# UNITED STATES PATENT AND TRADEMARK OFFICE

APPLICATION NO.	FILING DATE	FIRST NAMED INVENTOR	ATTORNEY DOCKET NO.	CONFIRMATION NO.
09/750,504	12/26/2000	Junji Yoshida	6635-60104	6968

**Office Action Summary**

F I G. 1

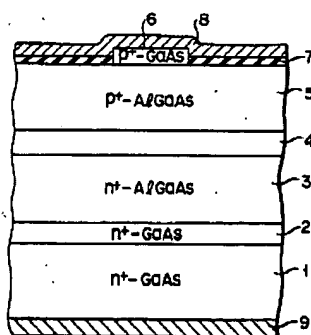
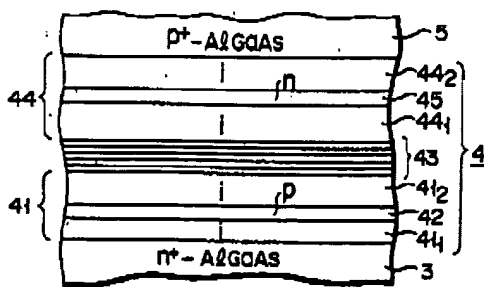
9. Claims 1-3, 5-15, 17-19, 29, 34, 36-38, 40-43 are rejected under 35

U.S.C. 102(b) as being anticipated by McIlroy et al (4,701,774). McIlroy et al discloses the claimed invention. Figures 1 and 2 illustrate a semiconductor laser device comprising a doped semiconductor cladding layer (3), a semiconductor optical layer (41<sub>2</sub>); and an undoped semiconductor spacer layer (41<sub>1</sub>) positioned between the cladding layer (3) and the optical confinement layer (41<sub>2</sub>). Note further the substrate (1), the semiconductor active layer (43) for generating light, a semiconductor upper optical confinement layer (44<sub>1</sub>); a p-doped semiconductor upper cladding layer (5); and electrodes (8,9) for current injection to the device. See col. 6 lines 60-63 for the suggestion of InP and InGaAsP.

FIG. 1

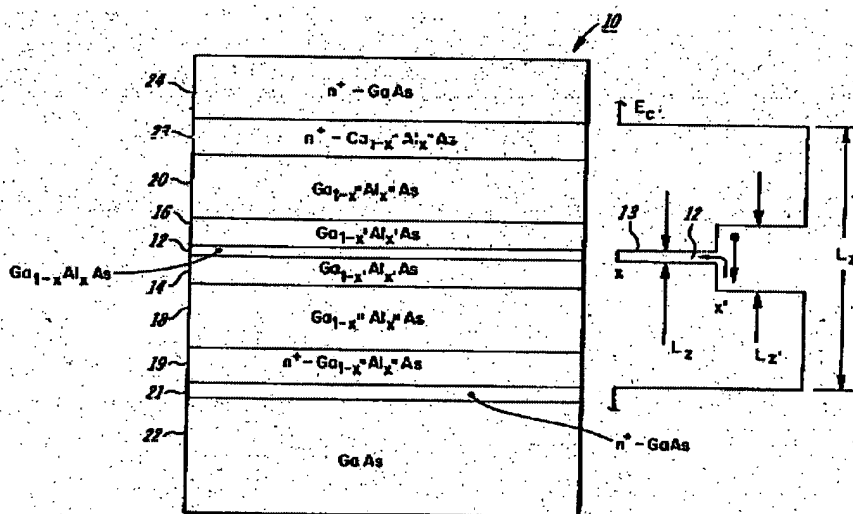
10. Claims 1-4, 6, 11, 29 are rejected under 35 U.S.C. 102(b) as being anticipated by Burnham et al (4,585,491). Burnham et al discloses the claimed invention.

Figure 1 illustrates a semiconductor laser device (10) comprising a doped semiconductor cladding layer (19), a semiconductor optical confinement layer (14); and an undoped semiconductor spacer layer (18) positioned between the cladding layer (19) and the optical confinement layer (14). Note further the substrate (22), the semiconductor active layer (12) for generating light.
